Re: H3-92
SUMMIT #148312 6/1/21 (MM)

Pages or sheets covered by this seal: I48228969 thru I48228973

Job	Truss	Truss Type	Qty	Ply	SUMMIT #148312 6/1/21 (MM)	148228969
H3-92	T7	Piggyback Base	1	1	Job Reference (optional)

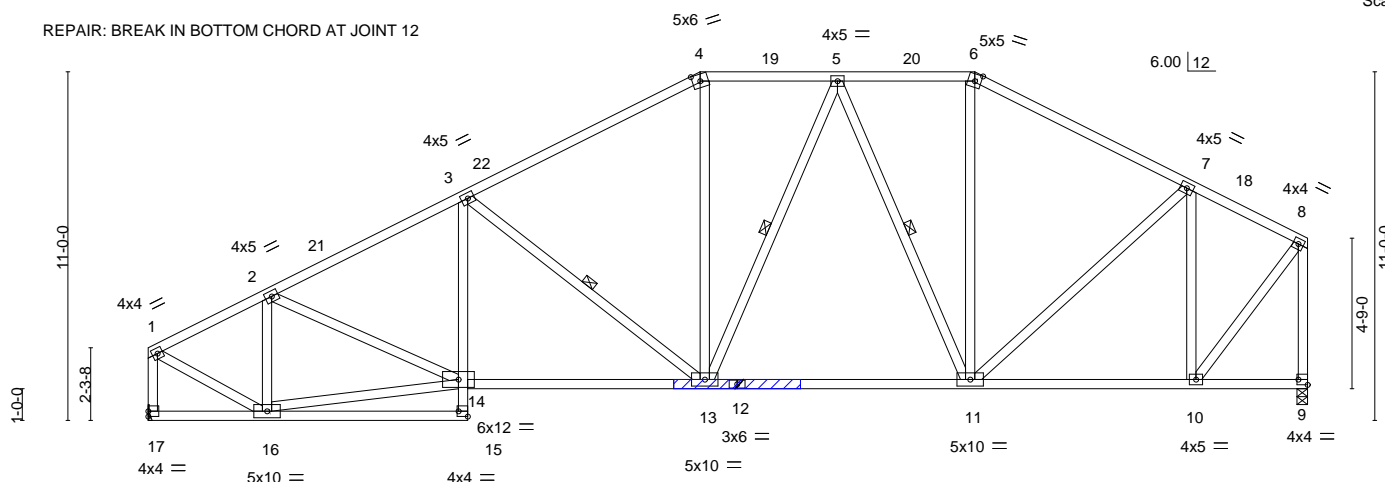
REPAIR: BREAK IN BOTTOM CHORD AT JOINT 12

APPLY 2 X 4 X 4' SP NO.2 SCAB(S) TO EACH FACE OF TRUSS CENTERED ON DAMAGE. ATTACH WITH (0.131" X 3") NAILS PER THE FOLLOWING NAIL SCHEDULE: 2 x 3'S - 1 ROW, 2 x 4'S - 2 ROWS, 2 x 6'S AND LARGER - 3 ROWS: SPACED @ 4" O.C. STAGGER NAIL SPACING FROM FRONT FACE AND BACK FACE FOR A NET 2" O.C SPACING IN THE TRUSS. USE 2" MEMBER END DISTANCE.
